# Sanford Street Municipal Parking Garage

## City of Attleboro ADA Transition Plan

March 2021

Institute for Human Centered Design

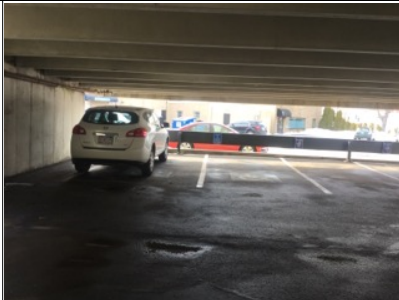
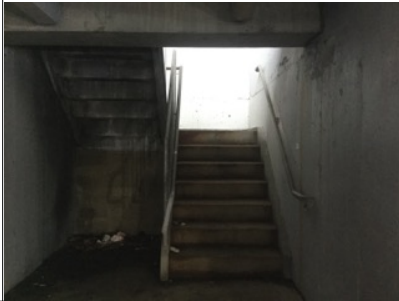
ID	Location	Floor	Room	Element	Type	Photo	Issues	Current Measure	Recommendations	Quantity	Price	Cost Estimation
<b>Approach and Entrance</b>												
<b>Exterior Access Route</b>												
1	Upper Level Parking by Exit	2		Exterior Access Route	Exterior		Surface openings > 1/2"	6"	Replace or reposition drainage grate.	1	100	\$100
2	Rear of the Buidling by Academy Street	Ext.		Exterior Access Route	Exterior		Level changes > 1/4"	3"	Alter change in level to be 1/4" high max.	1	256	\$256
3	Exit Near Condo Spaces and One Accessible Parking Space	1		Exterior Access Route	Walkway		Does not prevent accumulation of water	-	Ensure that water does not collect along the exit route.	1	Labor	\$0
4	Near Exterior Stair From Upper Level Parking	Ext.		Exterior Access Route	Exterior		Does not prevent accumulation of water	.5"	Repair surface.	1	256	\$256
5	Path on Right of Main Entrance	Ext.		Exterior Access Route			Does not prevent accumulation of water	-	Repair surface.	1	768	\$768
